### Commission of Architectural Review SUBMISSION APPLICATION

# 3 N Boulevard

Parcel ID W001202020, 3 N. Boulevard, was built in 1914. The picture was taken shortly after it was built. We propose to restore upstairs balcony, in kind, but to meet today's code.

Railing Baluster

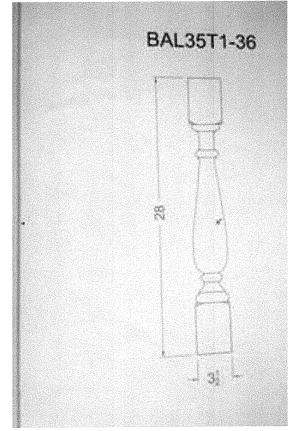
Thank you for stopping by this morning. It would be useful if you could provide the dimensions for the proposed railing as you had provided for the existing railing. You can just email me this information. Also, are you proposing to construct the balustrade out of wood?

- 1. 3-1/2" from deck floor to bottom support rail
- 2. 4" in bottom support rail
- 3. 33" in baluster
- 4. 1-1/2'' in top support rail

I would very much prefer to use custom millwork composite for durability and maintenance issues, which has been used quite often throughout the historic district areas. If wood is a must, I would consider it but again the best choice is the custom composite materials.
